PLAN OF PROPOSED IMPROVEMENT

REVISED BY EEA 8/17/2023

CITY PROJECT NO. 14343
CONTRACT NO. 9217

SOUTHERN ADDITION TO BIRCHWOOD POINT - PHASE 6

14343
O-1

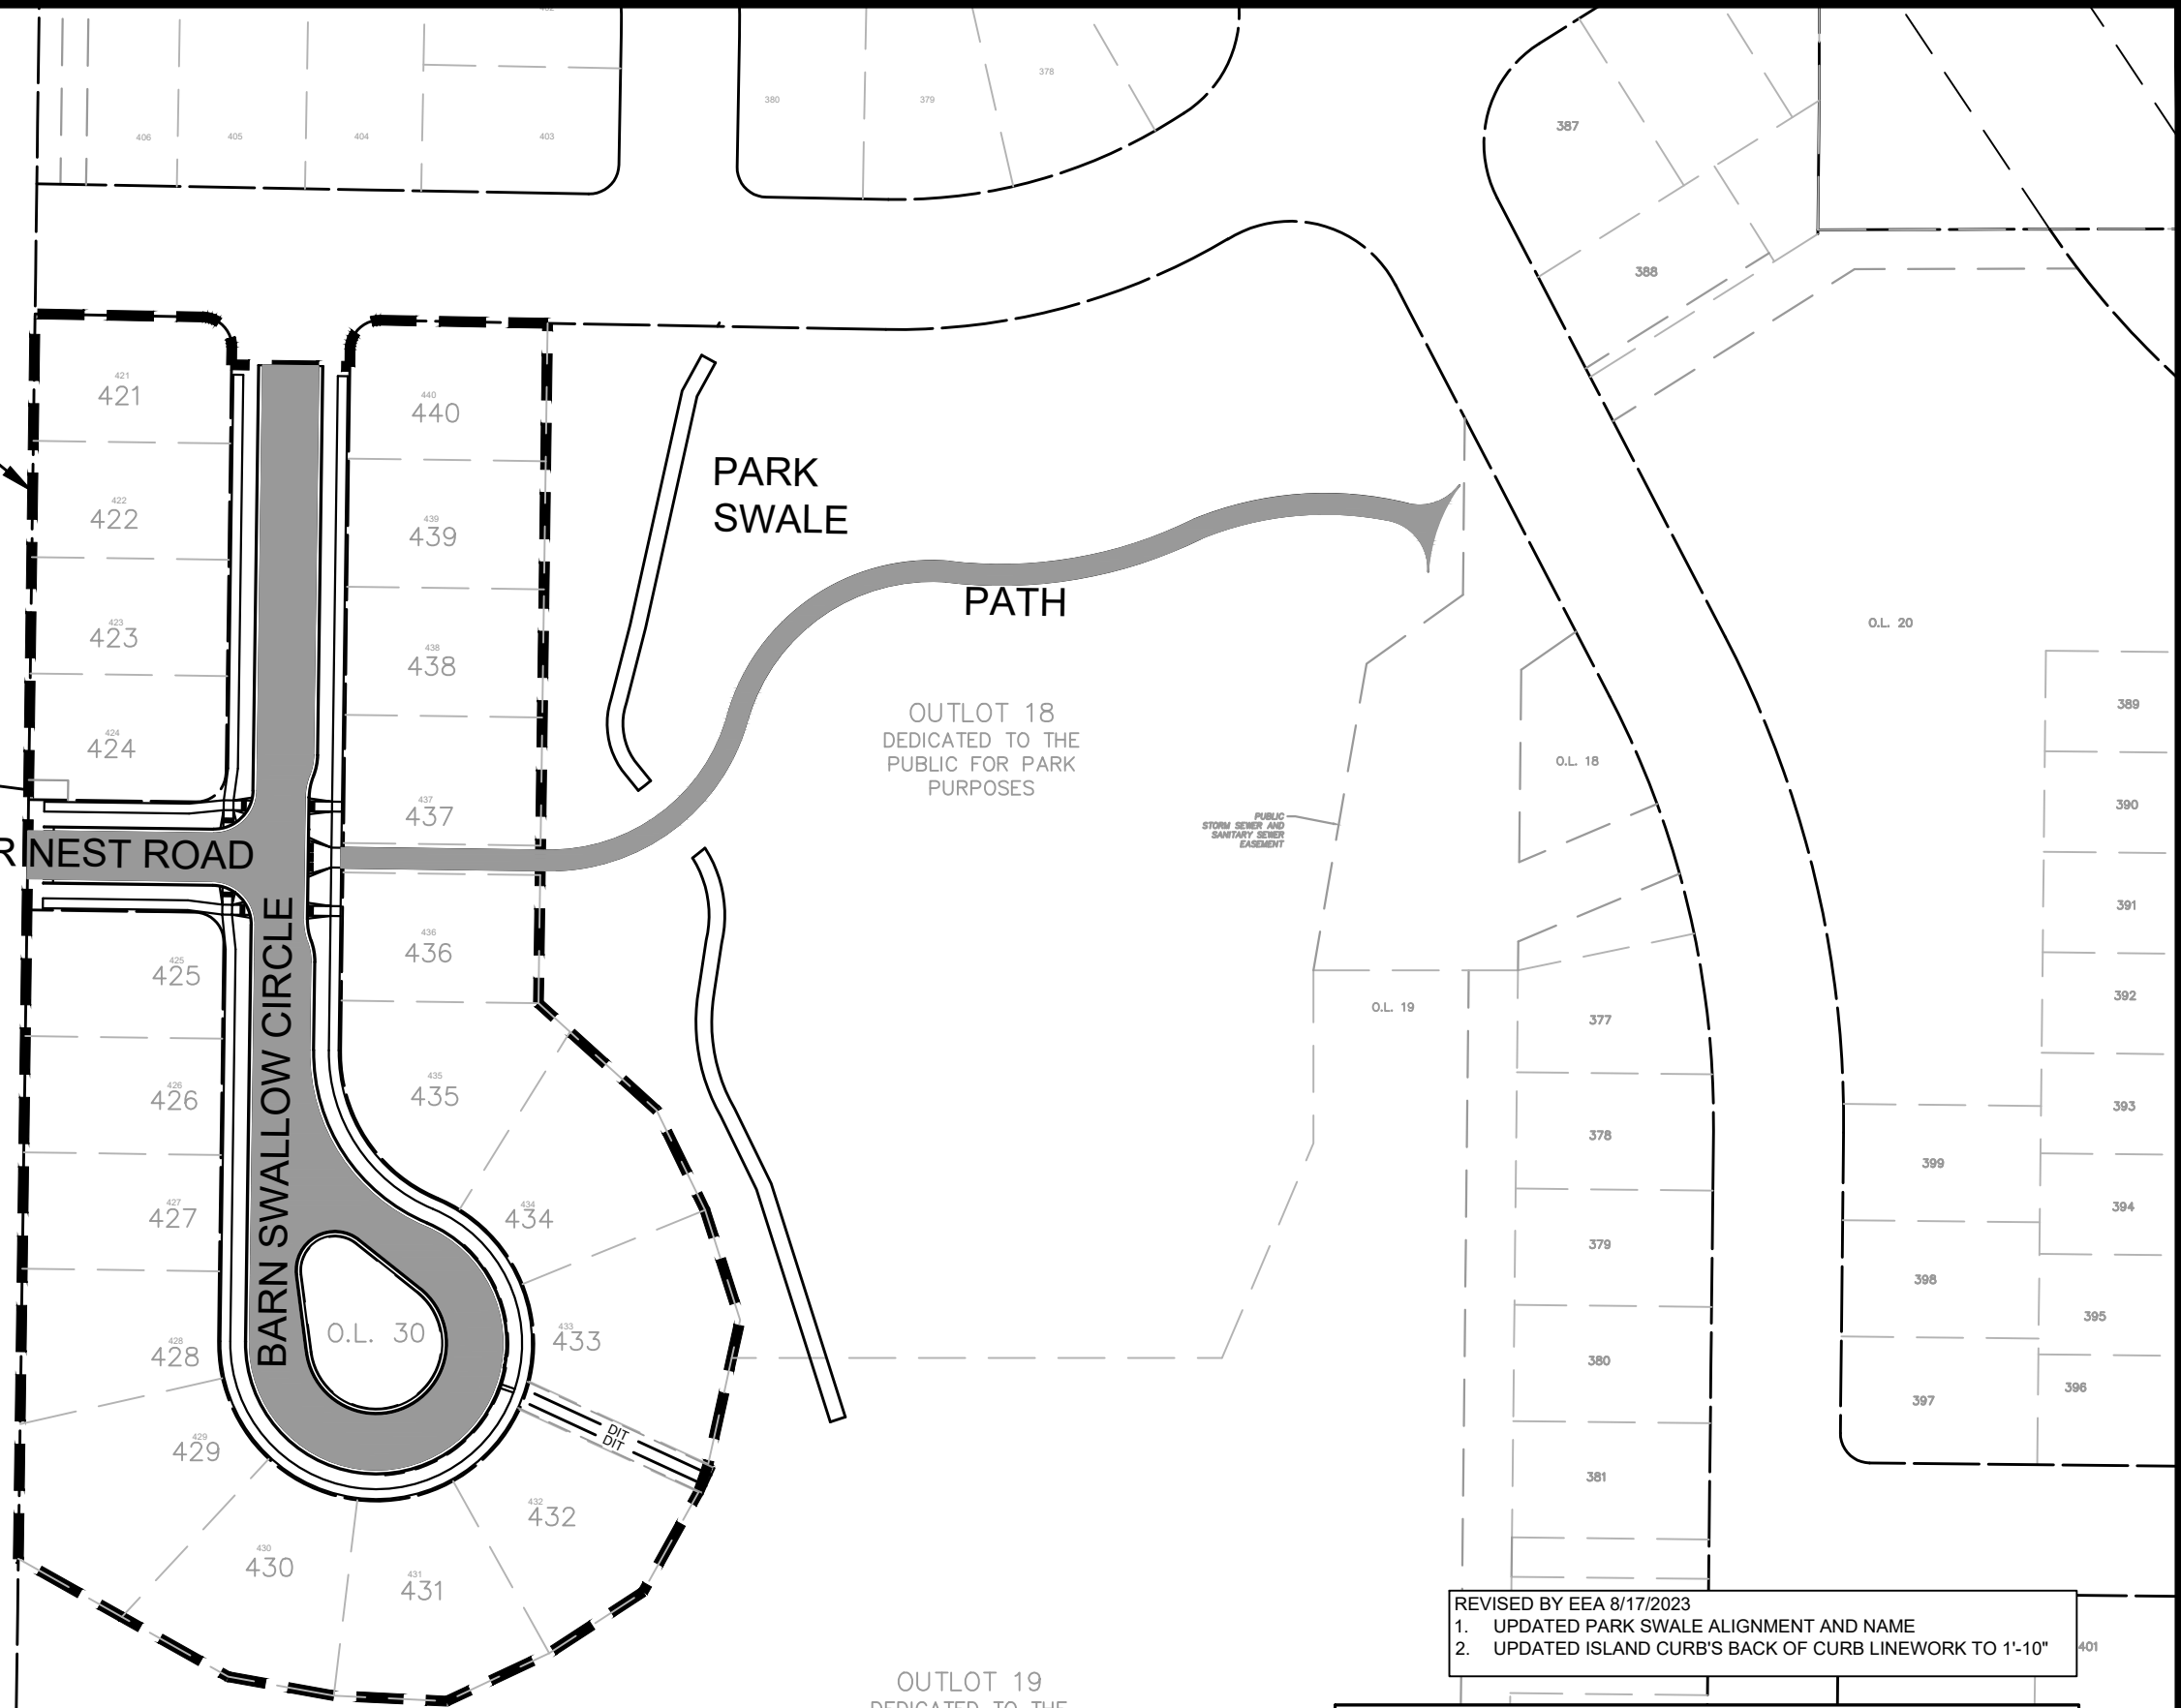
REVISED BY EEA 8/17/2023
1. UPDATED PARK SWALE ALIGNMENT AND NAME
2. UPDATED ISLAND CURB'S BACK OF CURB LINEWORK TO 1'-10"

14343	14343	9217	P-1A
MADISON, WI	CONTRACT NO.:	14343	14343
SOUTHERN ADDITION TO BIRCHWOOD POINT - PHASE 6	DESIGNED BY:	EA	11/17/2022 1:34 PM
PLAN & PROFILE - BARN SWALLOW CIRCLE	DATE:	11/17/2022	1:34 PM
CITY OF MADISON WISCONSIN	BY:	EA	EA
14343	MARK:	EA	EA
P-1A	REVISION:	EA	EA

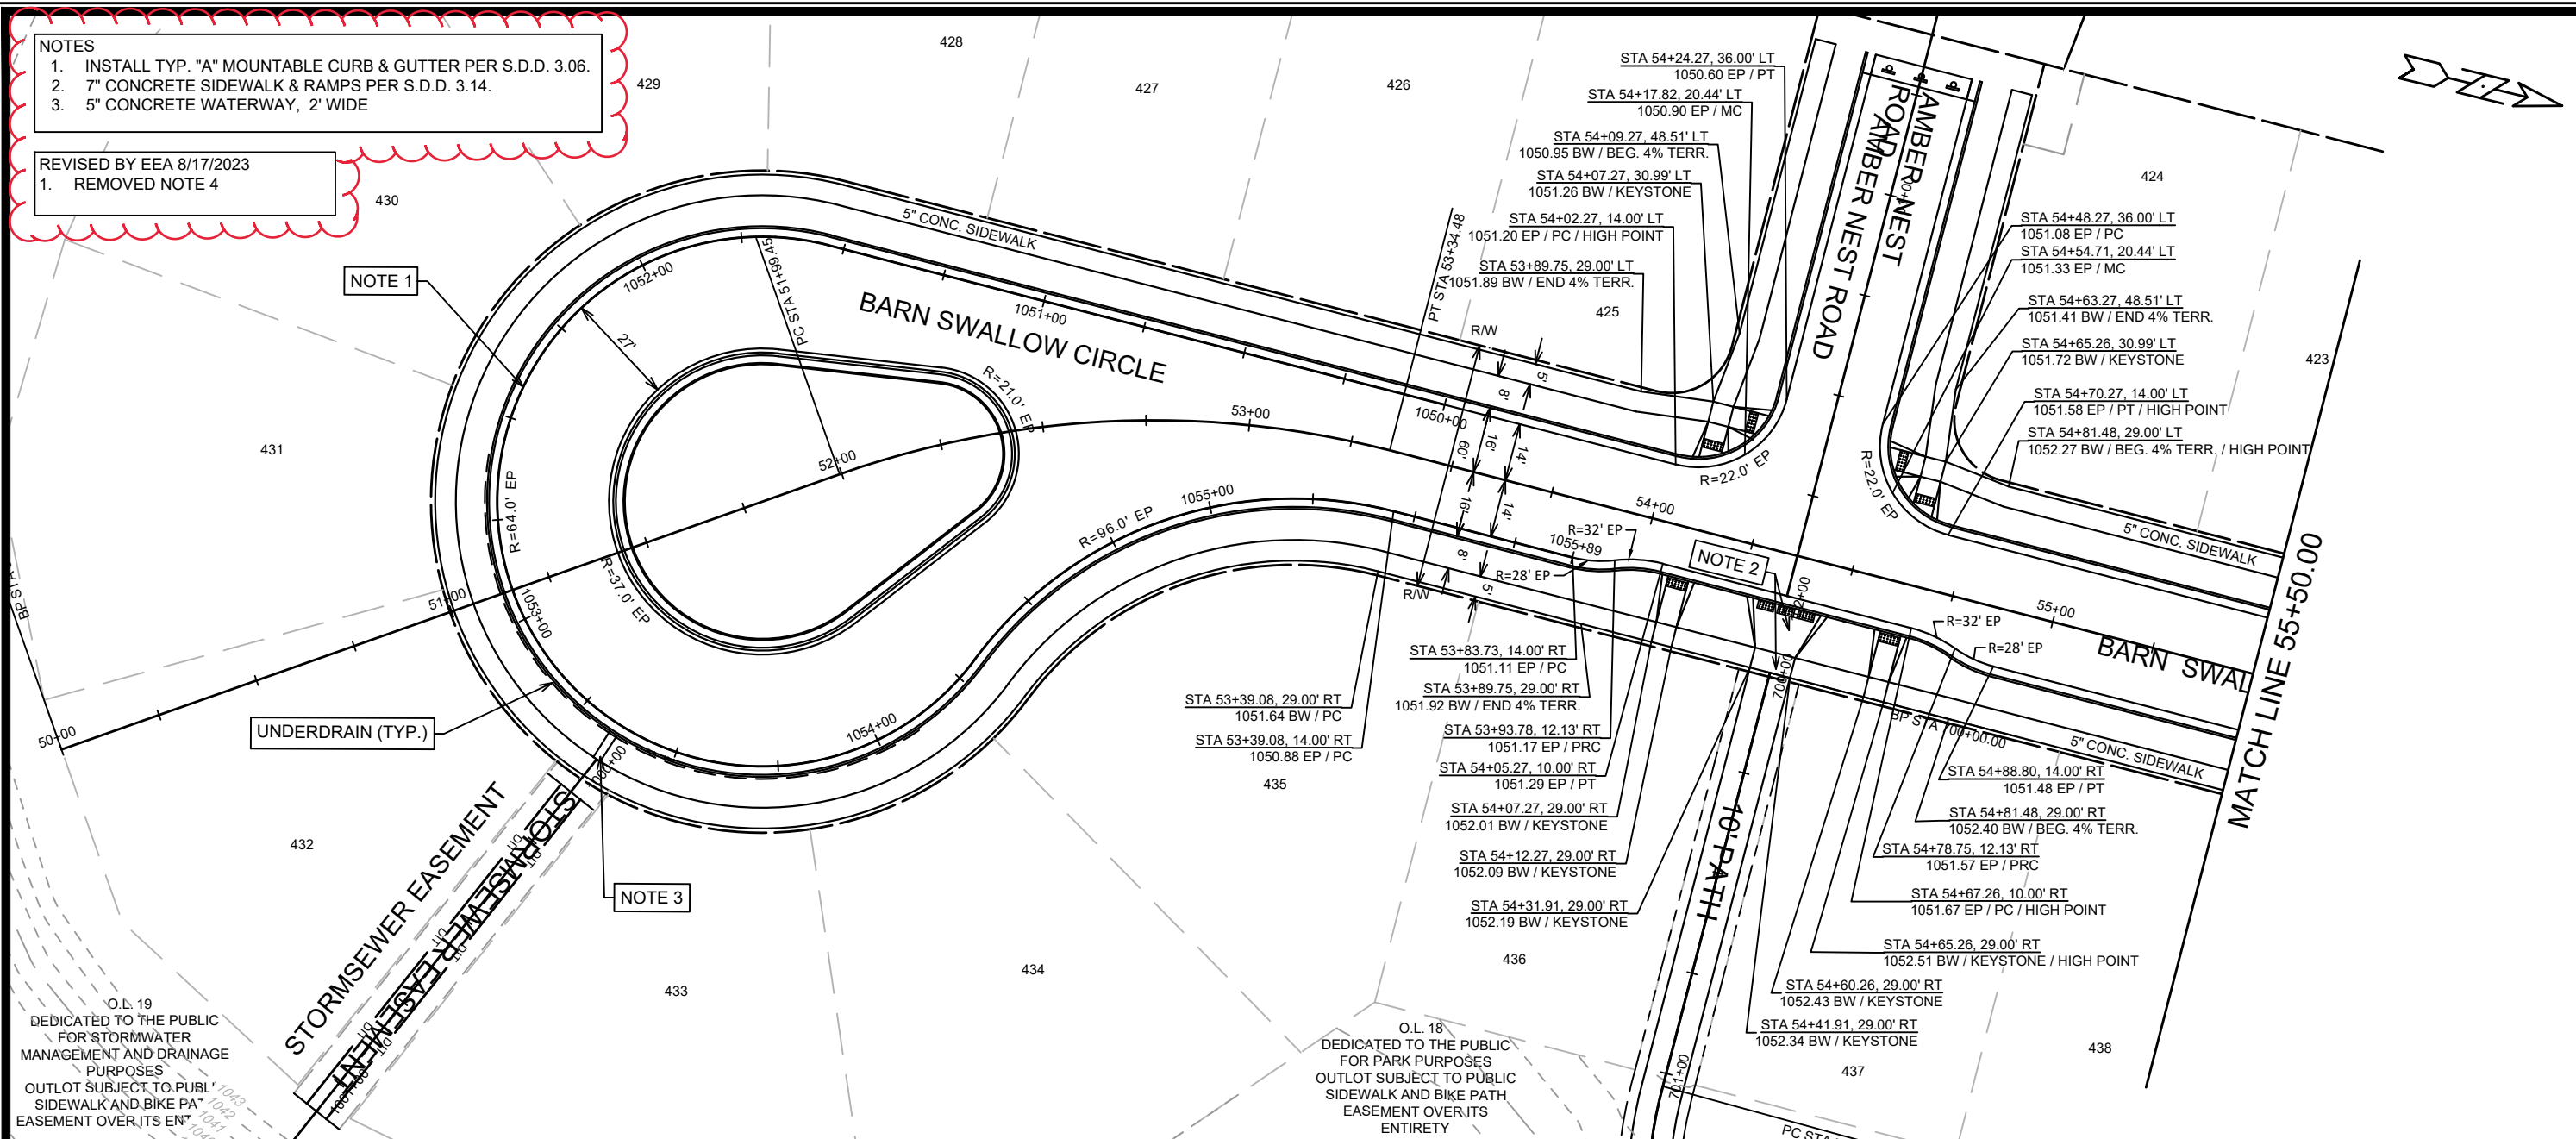
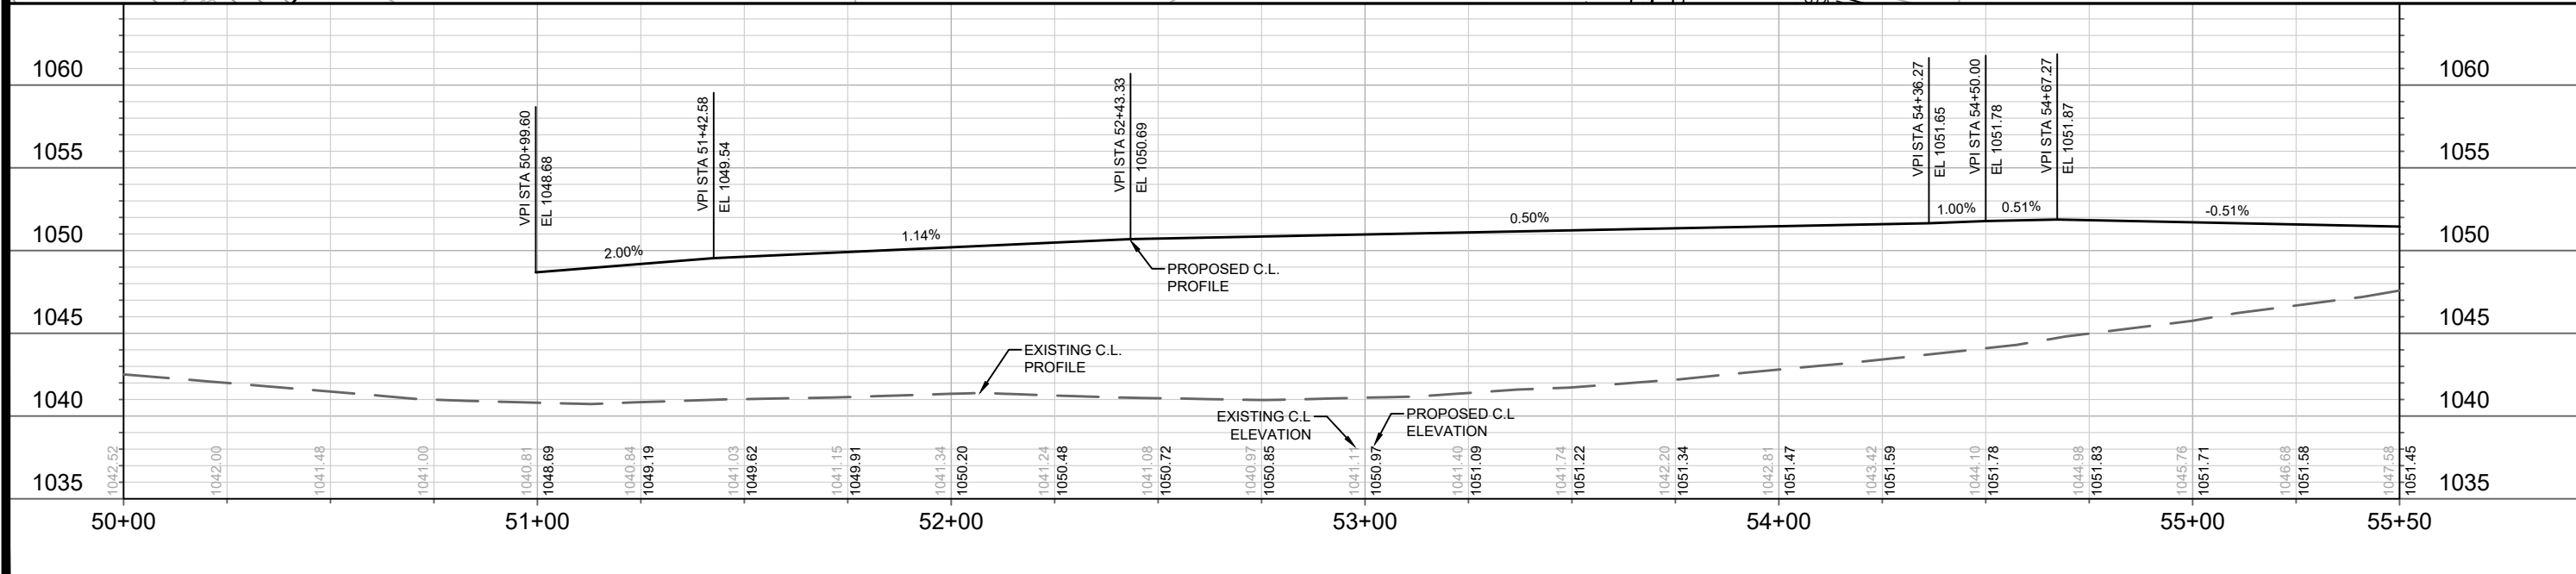
REVISED BY EEA 8/17/2023
1. REMOVED NOTE 4

14343 P-2	PLAN & PROFILE - BARN SWALLOW CIRCLE SOUTHERN ADDITION TO BIRCHWOOD POINT - PHASE 6	14343 MADISON, WI 9217 CONTRACT NO:
M:\DESIGN\Projects\14343\CAD\Streets\14343EN-PnP1.dwg	MARK: ### REVISION: ### DATE: ### BY: ###	Scale: ##### Date: 11/7/2022 1:33 PM

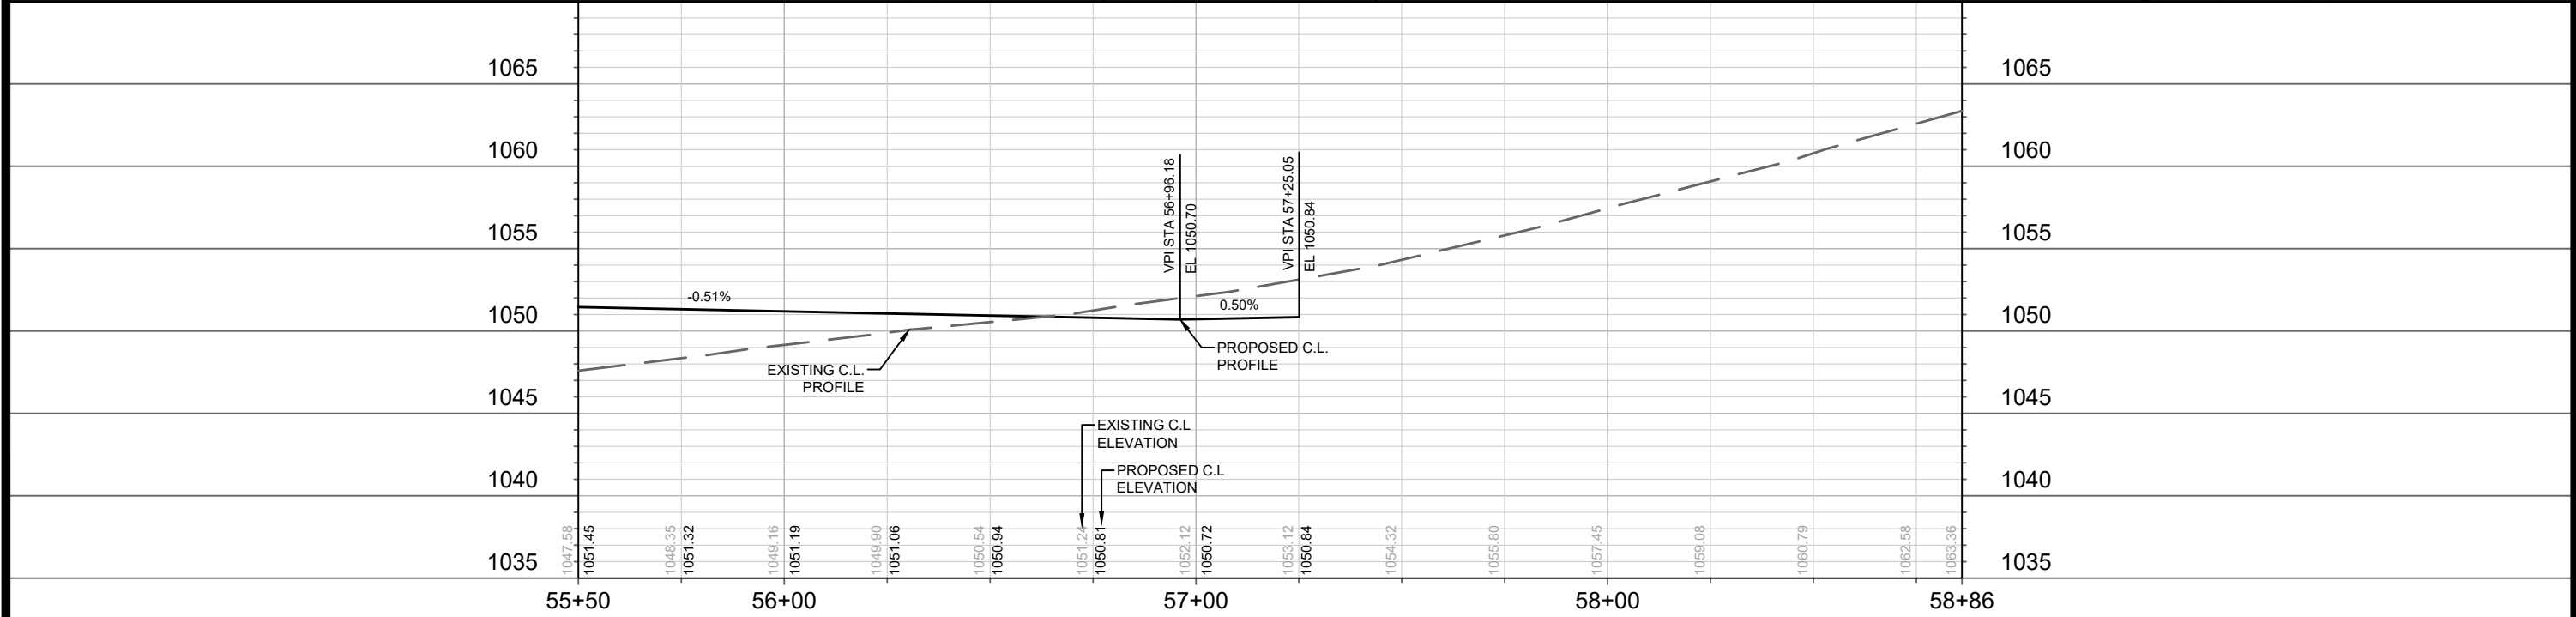
- REVISED BY EEA 8/17/2023
1. REMOVED NOTE 3
 2. ADDED PARK SWALE LABEL
 3. UPDATED PARK SWALE ALIGNMENT
 4. UPDATED 10' ASPHALT PATH DITCH AND SLOPE INTERCEPT
